# Access Compliance Report

## Public Rights-of-Way

### (Curb Ramps)

Intersection ID: N/A	Main Street: GANNON_DR	Cross Street: RACHEL_FREEMAN_WY	Location: W
ADA ID: 0381F942F62A	Ramp Type: Perp	Initial Pass/Fail: Pass	Overall Compliance: No
Severity Score: 0			
Codes/Mitigation Info/Possible Solution		Field Measurements/Component Compliance

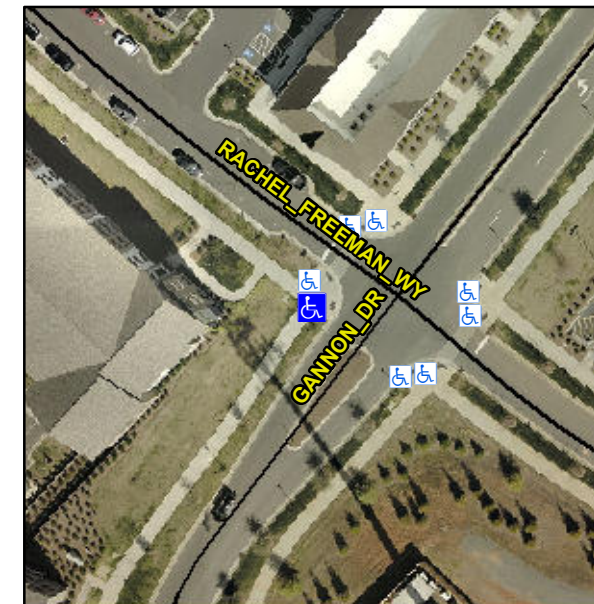
**Remove & Replace Detectable Warning System.**

**R305.2**
